# Eastern Creek Recycling Ecology Park Mod 12

Amendment of Approved Location of Landfill Gas Flare Compound  
State Significant Development Modification Assessment (MP06\_0139-Mod-12)

October 2022

Figure 3 | Proposed modification

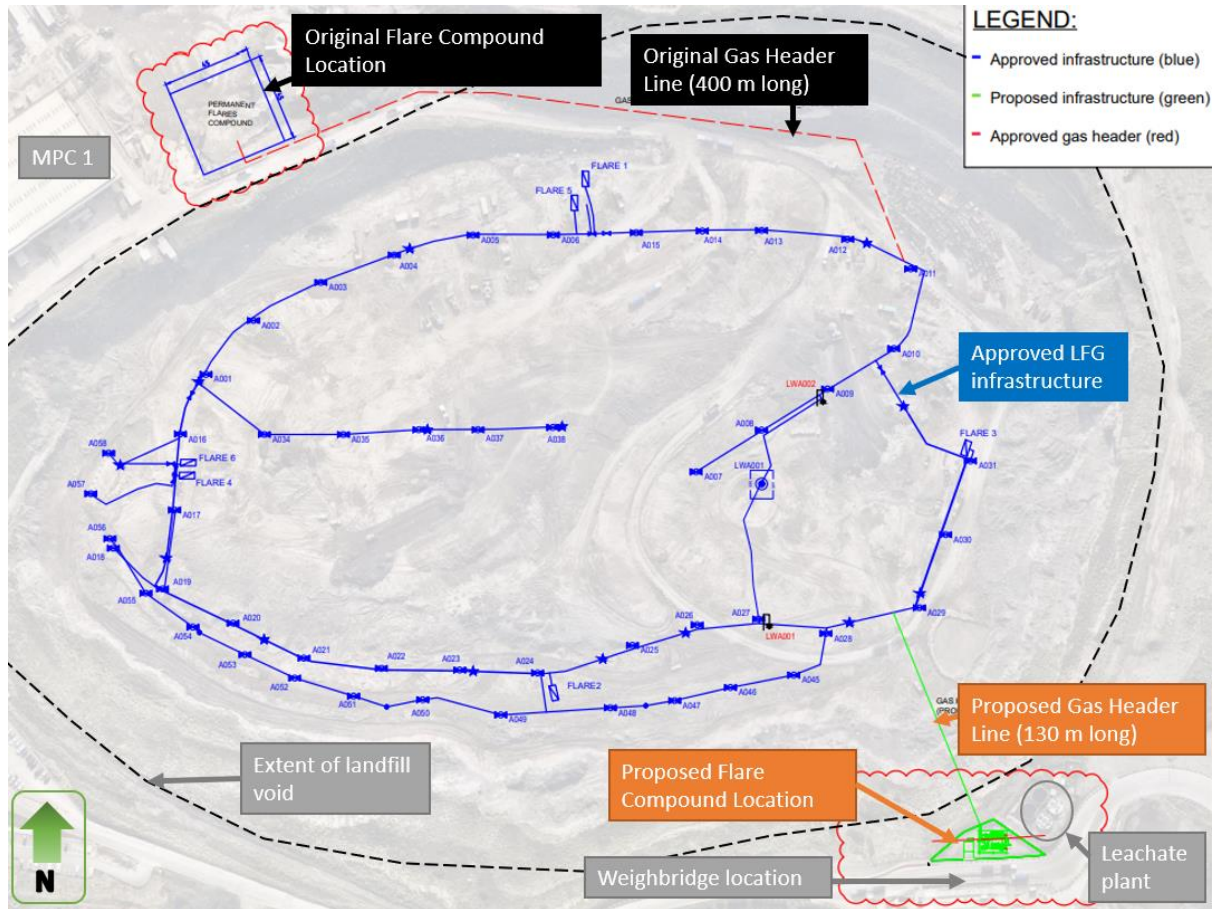
The Applicant has lodged a modification application under section 4.55(1A) of the EP&A Act to amend the approved location of two permanent LFG flares. The modification is described in full in the Statement of Environmental Effects (SEE) included in **Appendix A** and is illustrated on **Figure 3**. The modification seeks to:

- change the approved size and location of the compound containing the two permanent enclosed LFG flares to a location opposite the new weighbridge and adjacent to the existing leachate treatment plant. The flare compound includes:

- engineered concrete hardstand base (area 11 m x 13.8 m) for the flares (area of compound would be reduced from 646 m<sup>2</sup> to 153 m<sup>2</sup>)

- two LFG flares (Run Energy model OEF-300) each with a capacity of 1,500 Sm<sup>3</sup>/hr
  - a stainless-steel condensate knockout pot
  - a storage shed (5 m x 5 m) for storage of general operational equipment for the flares

- 1.8 m high palisade security fence (total length of 126 m) around the flare compound, including a 5 m double entry gate for access to the storage shed

- change the height of the approved flares from 8 m to 10 m (stack height RL 93.7 m)
- change the length and location of the main gas header line (450 mm) leading from the LFG collection system in the landfill void to the flares. The length of the main header line would be reduced from 400 m to 130 m.
